# UNITED STATES PATENT AND TRADEMARK OFFICE

APPLICATION NO.	FILING DATE	FIRST NAMED INVENTOR	ATTORNEY DOCKET NO.	CONFIRMATION NO.
10/538,809	12/23/2005	Christophe Mathoulin	0573-1020	5678
466	7590	10/04/2006	EXAMINER	
YOUNG & THOMPSON 745 SOUTH 23RD STREET 2ND FLOOR ARLINGTON, VA 22202			WOODALL, NICHOLAS W	
			ART UNIT	PAPER NUMBER
			3733

**Office Action Summary**

## **DETAILED ACTION**

Figure 1

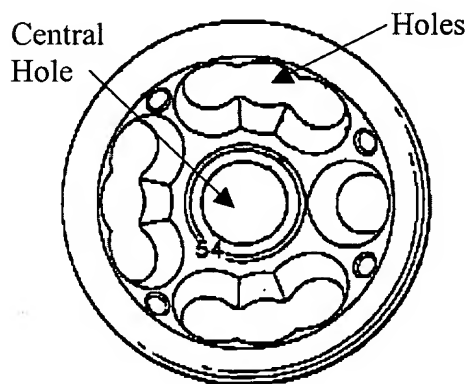
Regarding claim 1, Huebner discloses a device comprising lateral holes and a flat face (reference Figure 1 below). The holes are at an angle to direct the screws

towards the outside edge of the plate. Huebner shows various embodiments of the device, one including a flat face that contacts the surface of the bone. Regarding claim 2, Huebner further discloses a device that is circular in shape. Regarding claims 3 and 4, Huebner further discloses a device wherein the upper face comprises a recess (claim 3). The recess occupies a majority of the upper face of the device and is the form of a hollow spherical cap (claim 4). Regarding claim 5, Huebner further discloses a device further comprising at least one screw hole in the form of a hollow spherical section and a screw with a matching head to allow a multidirectional orientation of the screw (reference Figure 2 below). Regarding claim 6, Huebner discloses the device further comprising a number of holes close to the number of bone being treated. In one embodiment, Huebner shows a device comprising four holes to allow screws to pass into four different bones.
